20 December 2024

Mod2024/0710 – PAN-496055
46 NARRABEEN PARK PARADE – WARRIEWOOD, NSW
4.55 DESIGN MODIFICATION - ARBORICULTURAL REPORT
Ref No: 13324

Gartner Trovato Architects, project no: 2229

Figure 1: showing T2 SRZ & TPZ encroachment area

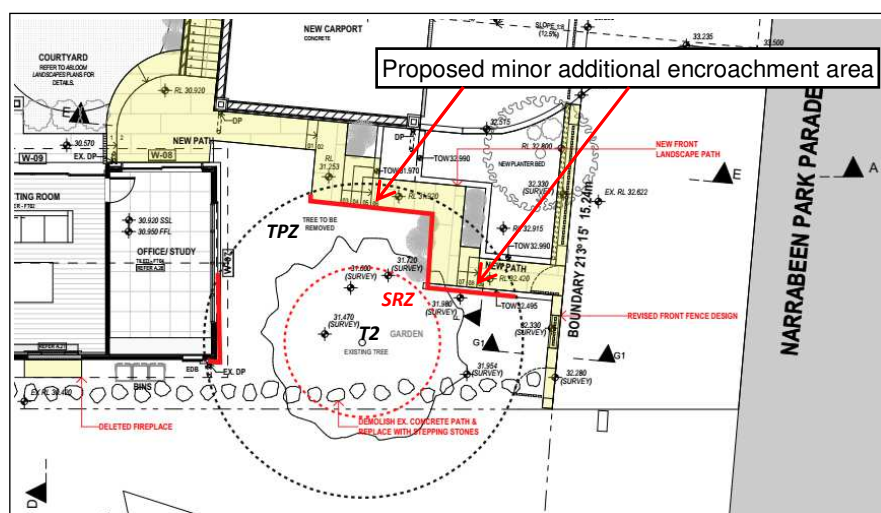
1. The design modification proposes a new pathway with stair access and front masonry wall adjacent one Coastal Banksia tree known as tree T2.
The subject tree has a 2.3m Structural Root Zone (SRZ) and 4.8m radial Tree Protection Zone (TPZ).
2. Based on the design modification, no new works are proposed within the SRZ being *the area required for tree stability* (AS4970)

Additional new encroachment within the TPZ is of a *Minor* (<10%) TPZ occupancy at or near 9.2% with original dwelling occupancy at 2.1%. The overall combined occupancy within the TPZ is considered a *manageable* (<15%) *low-level* impact of at or near 11.3%.

Given the overall *low-level* and manageable TPZ occupancy the design proposal is considered as having likely no to very *Minor* impact to the tree.

3. Given excavation for footings are required within TPZ and very close to the SRZ radius the following recommendations are provided to mitigate impacts by the design proposal:

- a) Tree protection fencing is to remain as indicated within the original 2022 Arboricultural Impact Assessment (AIA) report ensuring the SRZ to the east of the tree is adequately protected.

- b) There is to be no access or excavation within the 2.3m SRZ radius without prior arborist advice & certification. Where access for construction is required the SRZ is to be protected with ground protection mats or similar.

- c) Excavation for footings within the TPZ are to be conducted manually (by hand) for the first 0.5m (500mm) being supervised & certified by an appointed AQF Level 5 certified arborist.

- d) All encountered tree roots are to be clean cut in accordance with AS4970 – 2009 Section 4.5.4 *Root protection during works within the TPZ*, such that tree roots are not damaged or ripped beyond the point of excavation by site machinery. All cuts are to be clean cuts made with sharp tools such as secateurs, pruners, handsaws, chainsaws or specialized pruning equipment as per Section 9 *Root pruning* of AS4373 Pruning of Amenity Trees 2007.

- e) No new additional excavation is to occur within the 4.8m Tree Protection Zone (TPZ) without prior project arborist advice & certification.
4. Based on the documentation assess no additional trees are affected by the proposed 4.55 design modification.
